Detailed Site Plan

DSP-18027

STAFF REPORT

SUBJECT: Detailed Site Plan DSP-18027
7-Eleven, Laurel-Baltimore Avenue

SHEET TITLE:
SITE PLAN
 SHEET NUMBER:
C-301

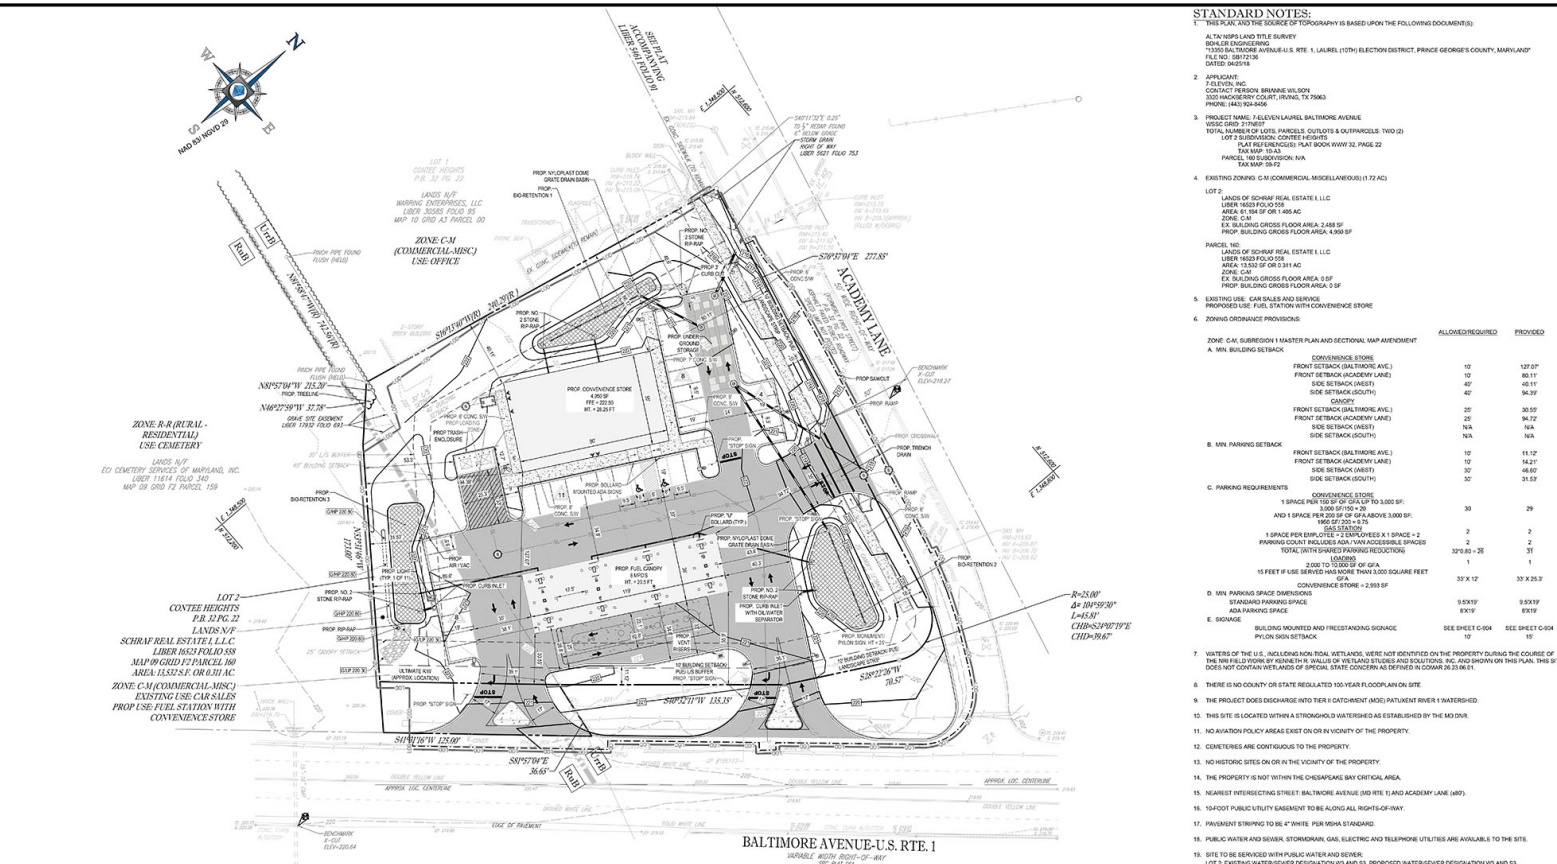
Site Plan – Sheet C-301:

1. In Standard Note 17, please clarify which pavement markings will be 4”. Per Maryland MUTCD standards, stop lines must be 24” solid white lines. Crosswalks must be 12” solid white lines. Edge lines must be 5” solid white lines if on the outside shoulder.
2. Please label or include a note regarding the proposed stop signs with the sign standard R1-1 and dimension 30” x 30”.

ELEVATIONS

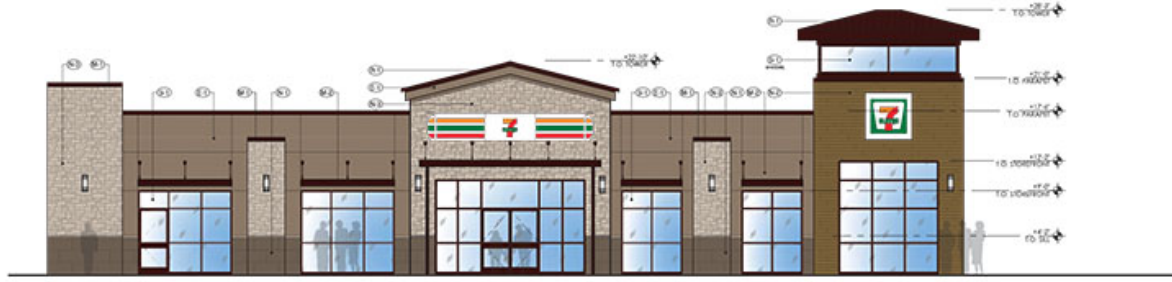
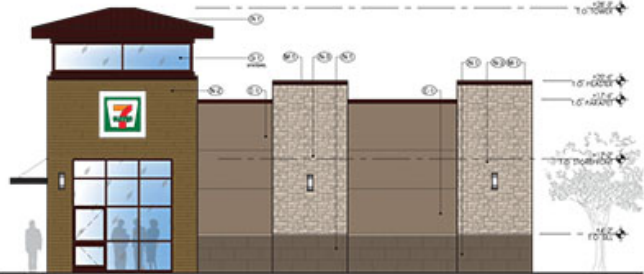
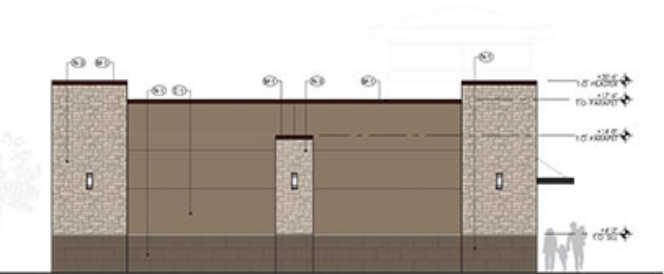
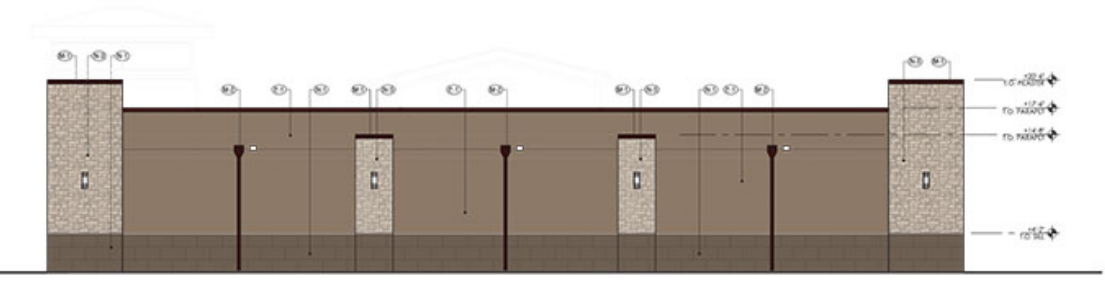
Architectural elevations are provided for the food and beverage store façade showing a masonry building. This section of Baltimore Avenue is characterized by commercial uses. Masonry is compatible with the surrounding development in the area.
